Job: TH - Walled Garden Buildings

Title: Buildings 18 & 19 - Typical Details P3

Status: FOR PLANNING

02 Buildings 18 & 19 - Typical Glasshouse Glazing Eaves & Gutter Detail
840.2 SCALE 1:5 @ A1

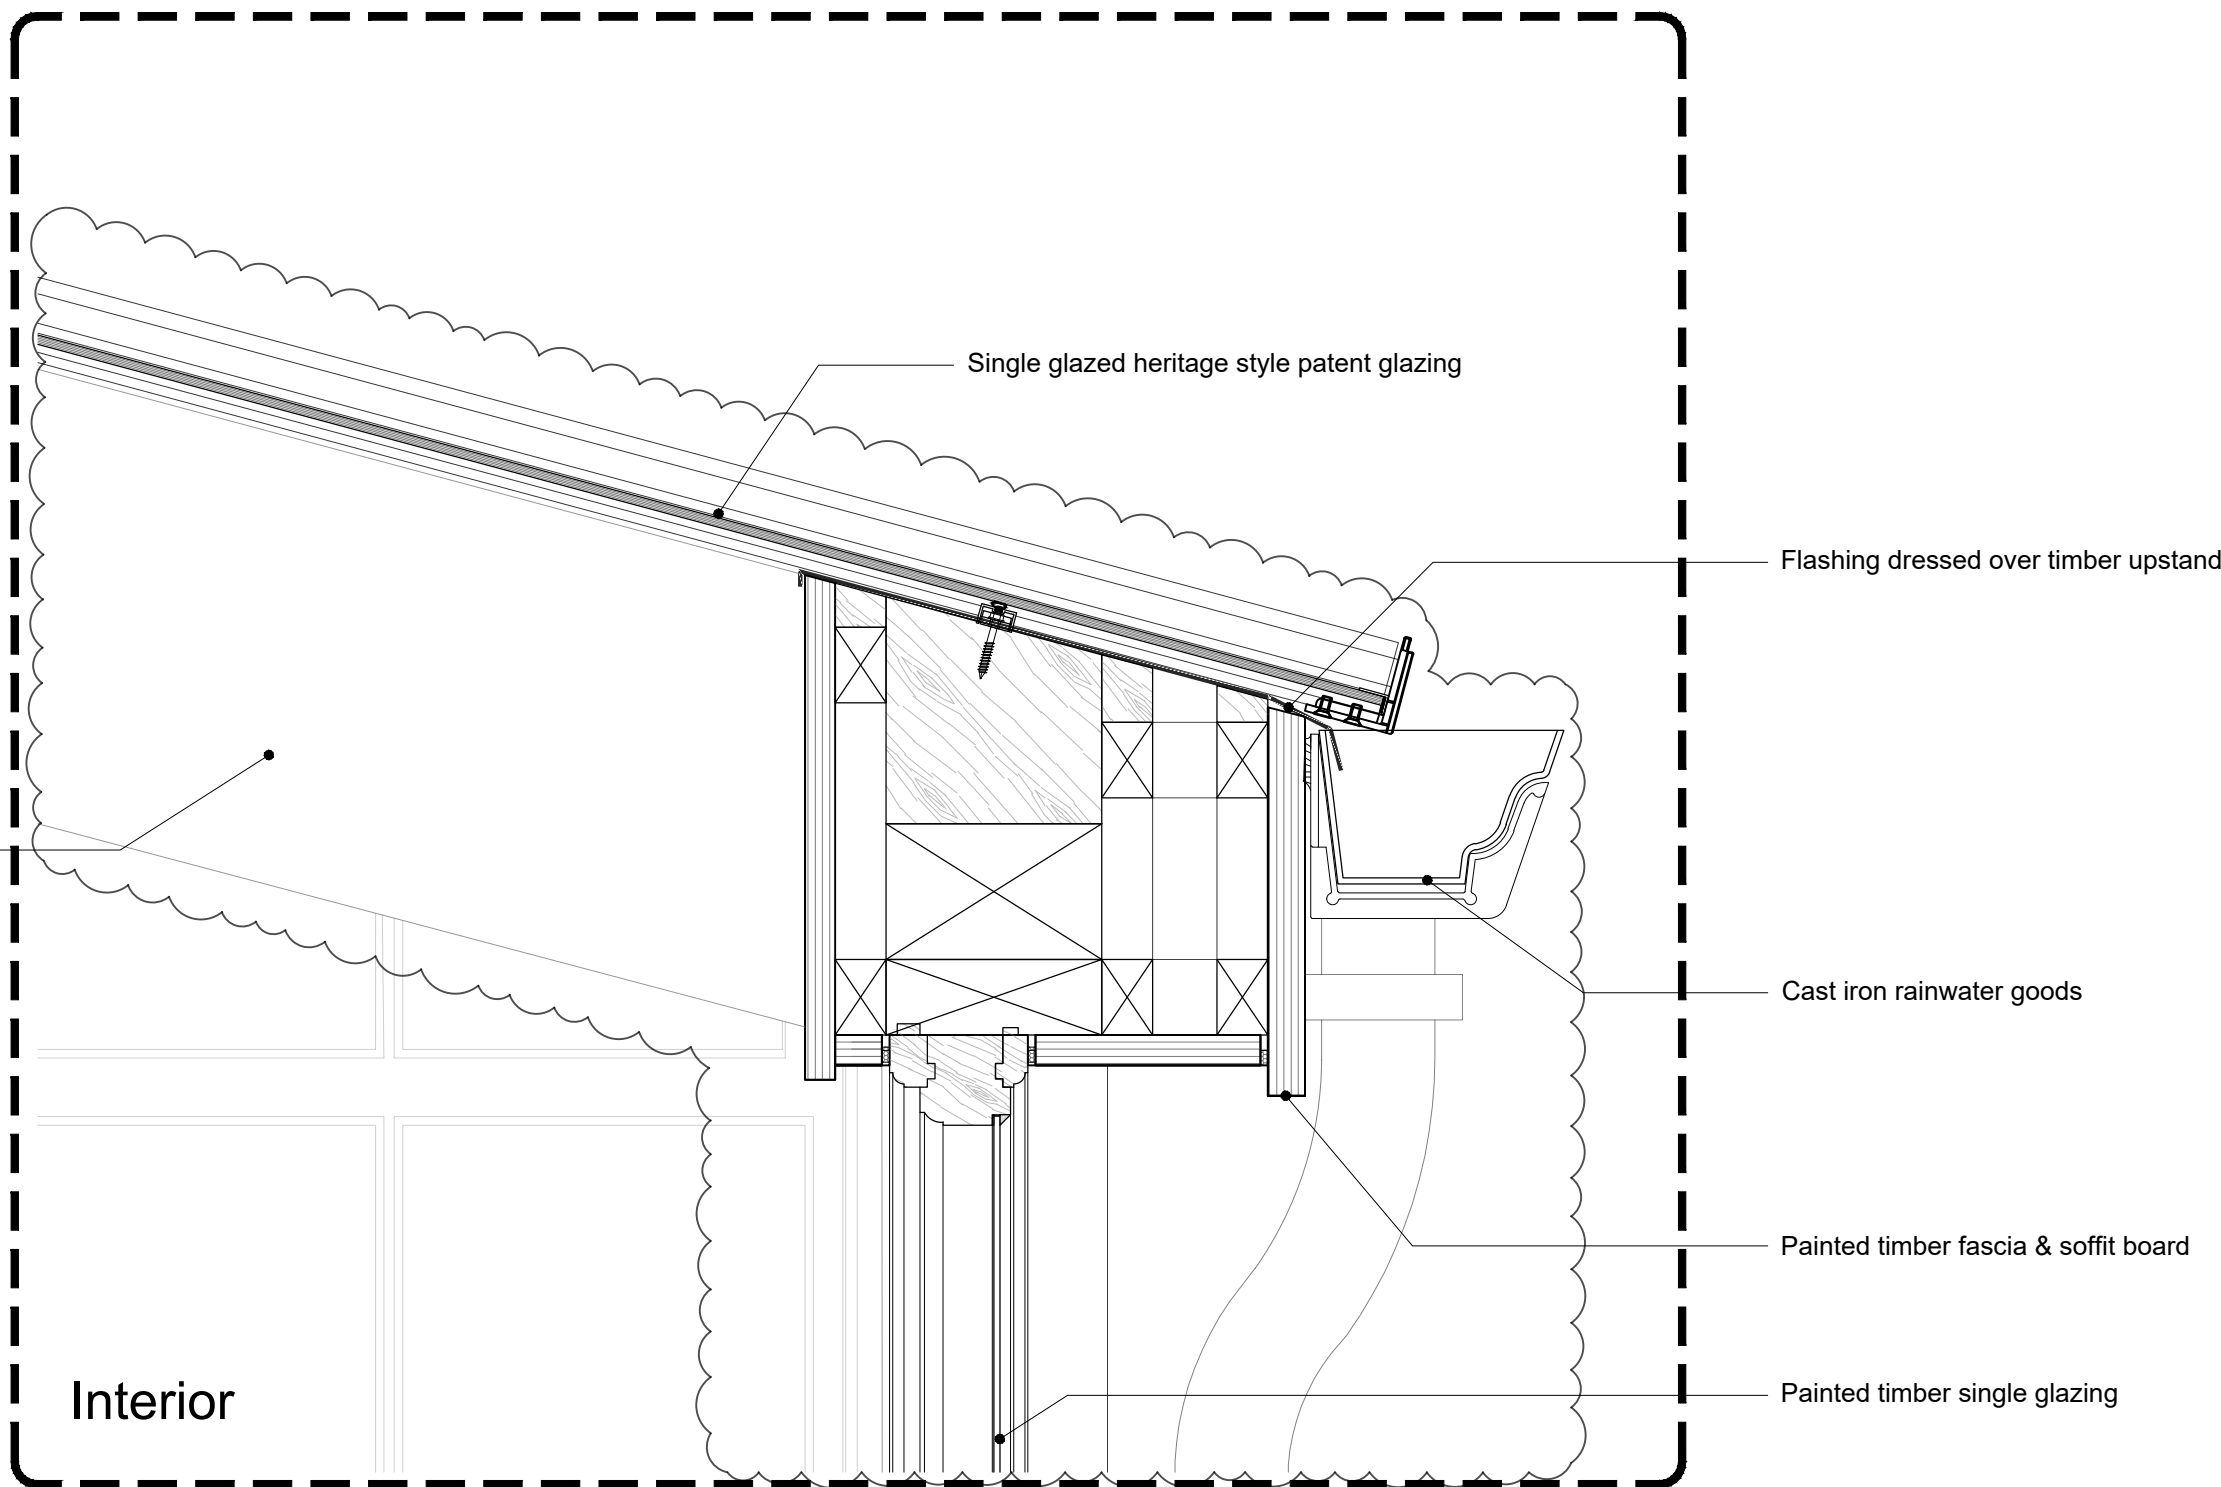
P3	Glasshouse roof glazing junction & footing/foundation amended according to SE design	15/06/26
P2	Timber bead and annotations amended	16/03/26
P1	Initial Release	dd/mm/yy
no.	revision.	date.
